Preliminary Plan **Woodlawn Drive Community** Cobb County, Georgia Land Lot 8, 17th District, 2nd Section

PETITION NO: Z-61

ZONING COMMENTS:

STAFF RECOMMENDATIONS

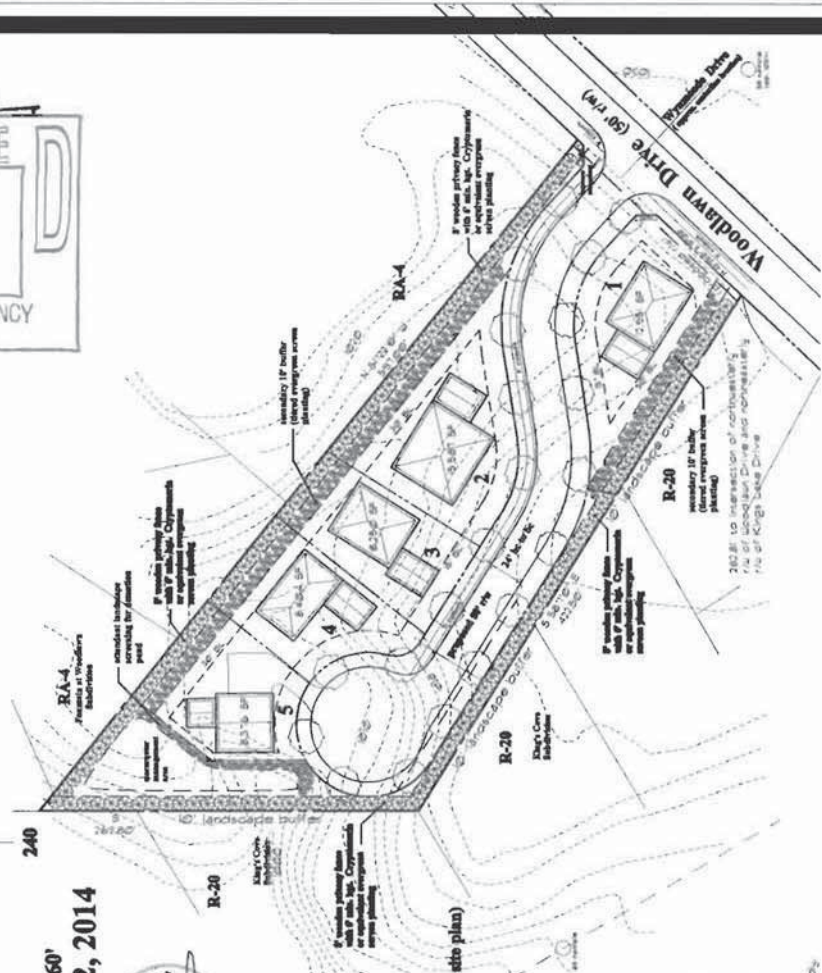
The applicant is requesting a contemporaneous variance to reduce the front setback from 20 feet to 15 feet and also to allow 30-foot rear setbacks instead of the required 40 feet as shown for Lots 2-5 and to allow the setbacks as shown for Lot 1 on the site plan received by the Zoning Division on September 23, 2014.

1. The entire site drains to the northwest into the Kings Cove Subdivision. However, there is no existing drainage easement to convey concentrated discharge from the site. The applicant is working with downstream property owners to obtain an easement to tie into the existing downstream storm system on Kings Lake Drive.
2. As indicated under Downstream Conditions, there is a private lake located approximately 500 feet downstream within the Kings Cove Subdivision. A pre- and post-sediment survey will be required.

Woodlawn Drive is classified as a minor collector and according to the available information the existing right-of-way does not meet the minimum requirements for this classification.

Recommend applicant consider entering into a development agreement pursuant to O.C.G.A. 36-71-13 for dedication of the following system improvements to mitigate traffic concerns: a) donation of right-of-way on the northwest side of Woodlawn Drive, a minimum of 30' from the roadway centerline.

Recommend curb and gutter along both sides and sidewalk along one side of proposed development roadway.

Recommend a taper for the Woodlawn Drive access.

Recommend applicant verify that minimum intersection sight distance is available for Woodlawn Drive access and if it is not, implement remedial measures, subject to the Department's approval, to achieve the minimum requirement of 390 feet.

Recommend development street either directly align or have an offset of a minimum of 125 feet from Wynmeade Park per Development Standard 401.10.

- Site plan received by the Zoning Division on September 23, 2014, with the District Commissioner approving minor modifications;
- Density not to exceed 2.5 units per acre;
- Fire Department comments and recommendations;
- Water and Sewer Division comments and recommendations;
- Stormwater Management Division comments and recommendations;
- Department of Transportation comments and recommendations; and
- Owner/developer to enter into a Development Agreement pursuant to O.C.G.A. §36-71-13 for dedication of system improvements to mitigate traffic concerns.
